Access Compliance Report Public Rights-of-Way (Curb Ramps)

Main Street: KENSINGTON_RD Cross Street: CHESNEY_DR Location: W

ADA ID: RPAT211201092031 Ramp Type: Type 1 - Perpendicular Diagonal Initial Pass/Fail: Fail Overall Compliance: No Severity Score: 15

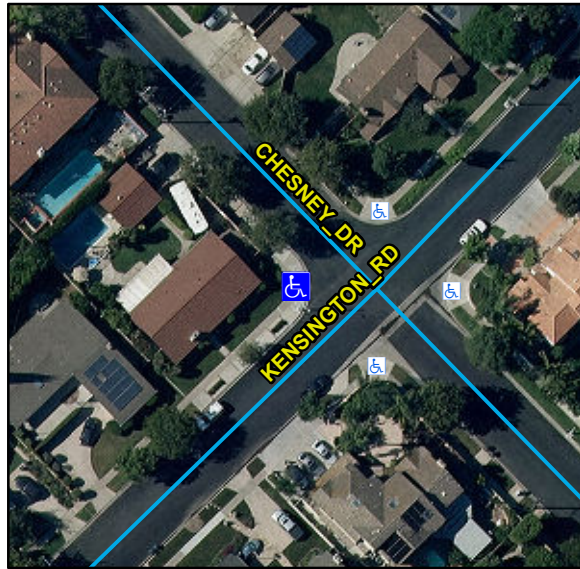
R204.3, R304.2.2, STD 1115

Remove & Replace Curb Ramp With Two New Directional Ramps or Equivalent.
